ENVIRONMENTAL PERMIT APPLICATION TO VARY PERMIT REFERENCE EPR/BN7109IH

MEGGITT AEROSPACE LIMITED

Response to further information request – May 2019

RESPONSE TO FURTHER INFORMATION REQUEST

Figure 2.1: Process Chemistry

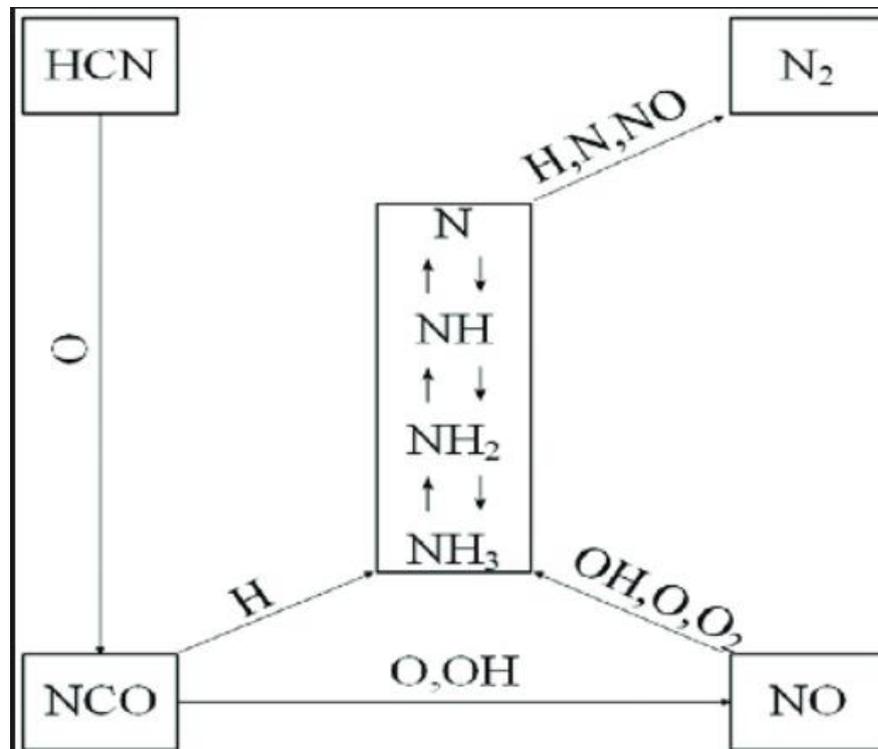
a. A technical explanation of the prevailing NO_x formation mechanism from this process (i.e. whether and to what extent NO_x are associated with thermal decomposition of chemically bonded nitrogen in OPAN raw material, thermal mechanism in the thermal oxidiser combustion process, fuel NO_x associated with the support fuel burned in the thermal oxidiser);

- The carbonising furnace directly exhausts the waste gas which is a highly concentrated stream containing pollutants such as hydrogen cyanide, carbon monoxide and ammonia in a nitrogen rich stream of low gas flow rate (~ 50 m³/h). This stream is directly vented into the combustion chamber of the thermal oxidiser. There is no NO_x produced in the carbonisation furnace process itself.

- The NO_x is formed in the Lesni thermal oxidiser from the oxidation of hydrogen cyanide (HCN) and as thermal NO_x from the burner.
- The gas burner type used is low NO_x burner type Maxon burner type kinemax 3". The burners use natural gas as a fuel and therefore this does not lead to the production of fuel NO_x.

- The new Lesni has a longer residence time to help with the process and reduce the emission levels.
- The ammonia produced as a by-product from the carbonising process acts in the same way as if there was to be selective non-catalytic reduction (SNCR) fitted to the system and subsequently reduces NO_x emissions hence eliminating the need for an SCR chamber and the ammonia dosing.

- NO_x emissions are largely influenced by the amount of HCN produced in the carbonising furnace and often there will be little NO_x produced.
- Further details of the chemistry of the process can be found in figure 2.1 below

Figure 2.2: Process Chemistry

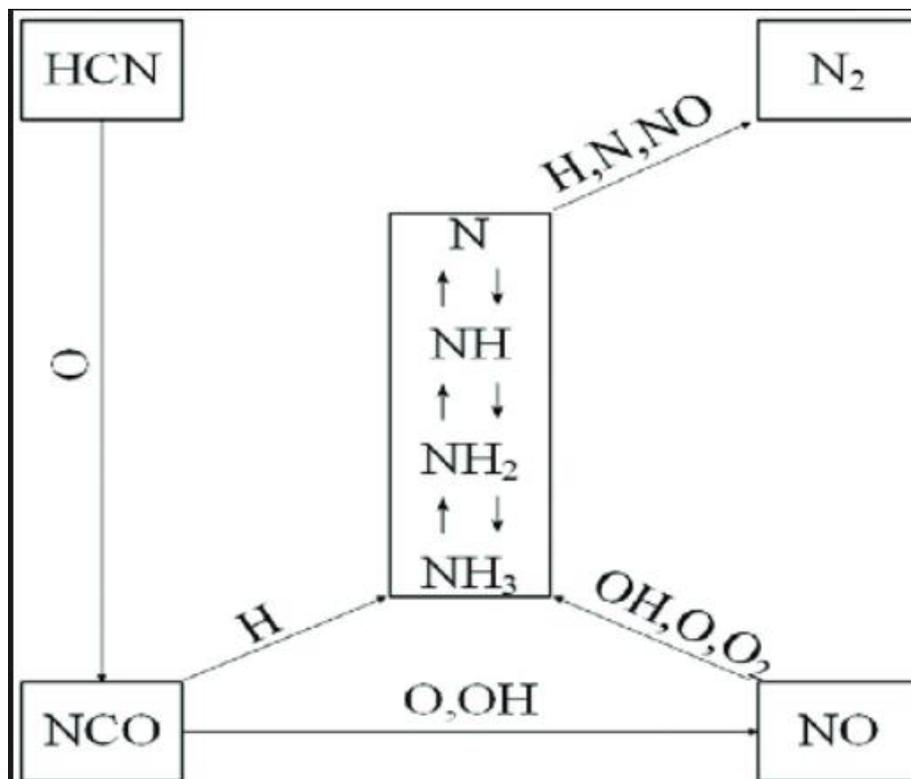
Confirm whether the thermal oxidation process will be effective in abating ammonia in the off-gas from the carbonizing furnaces to an extent that emissions of this pollutant are negligible; if ammonia is emitted, you need to submit an impact assessment for this pollutant as well;

- 2.5.1 Ammonia is produced as a by-product from the carbonising process, however, it acts in the same way as that of a selective non-catalytic reduction (SNCR) system and subsequently reduces NOx emissions forming nitrogen and water in the process. Ammonia emissions from the thermal oxidiser are considered negligible based on previous monitoring of ammonia emissions from the current thermal oxidiser. The current thermal oxidiser previously had a selective catalytic reduction (SCR) system but this was subsequently removed due to the ammonia produced in the furnace process being sufficient to reduce NOx emissions.

- 2.5.3 Due to the ammonia being present in the gases from the carbonising furnace, the technology provider has stated that is not a requirement to include ammonia injection to abate NOx emissions, Ammonia shall be monitored during commissioning to demonstrate ammonia emissions are insignificant.

- 2.5.4 Further details of the chemistry of the process can be found in figure 2.1 below:
